Hebron Project Comprehensive Study Report – Spill Trajectory Modelling: ECMP Response to Comments from Regulatory Authorities

Hebron Project Comprehensive Study Report Nearshore Bull Arm Spill Trajectory Modelling Report July 2011 Revision with Track Changes

Figure 2.5-9 (Page 20)

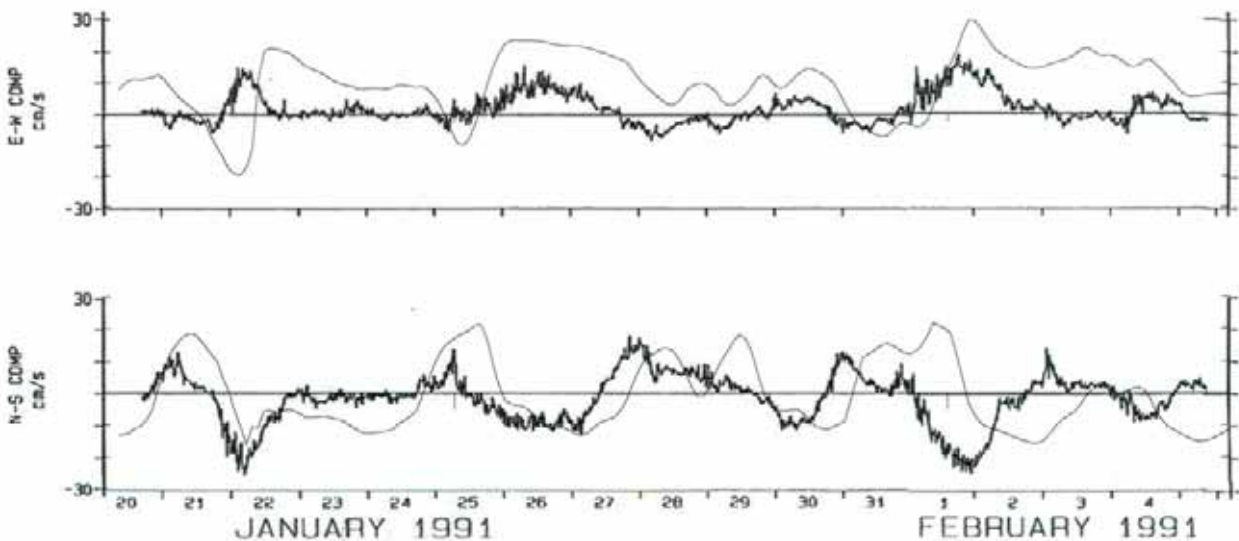
It would be valuable to have these two plots overlaid so it can be seen how the model fits the data. By superimposing the print out versions, one can see model-data differences up to 50

cm/s for an event near January 21st. Model-data discrepancies appear to be around 10-20 cm/s leading to drift errors of 10-20 km per day.

Response: The plot below shows the model predicted currents (smooth line) overlain on the measured currents at the Bull Arm site for the period January 20 through February 5. This figure will be included in the Nearshore Spill Trajectory Report. As can be seen in the plot, the agreement between the model predicted currents and the measured currents at the Bull Arm site show that the model both under-predicts and over-predicts currents at times. Considering the data over a 30-day period (the time frame for the oil spill simulations), the model predicted currents are doing a good job of representing flow at the site.
